Customer Service Bulletin Commercial Business Group

Groundsmaster® 580-D

Subject: **Availability of Hose Routing Kit (93-9956).**

HOSE ROUTING

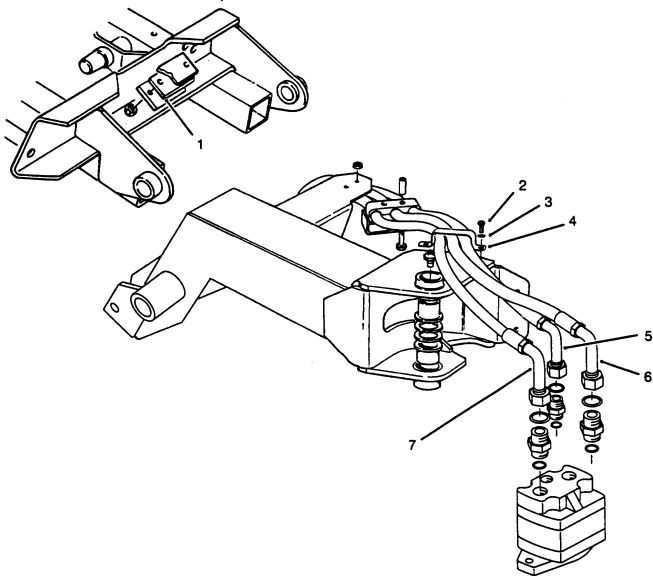
The internal routing of the wing unit hoses through the wing arms requires accurate hose positioning or the hoses may become damaged as the cutting units are raised and lowered.

In order to reduce hose damage due to incorrect routing, Hose Routing Kit (93-9956) is now available for the units identified above. The kit contains all the parts, hoses, and instructions necessary to reroute the wing deck hoses external to the arms. A parts page is located below as a reference. The external routing reduces the possibility of damage due to incorrect routing. All future production will include the external hose routing.

Some removal of sheet metal by cutting will be required to install this kit. Details are listed in the kit instructions.
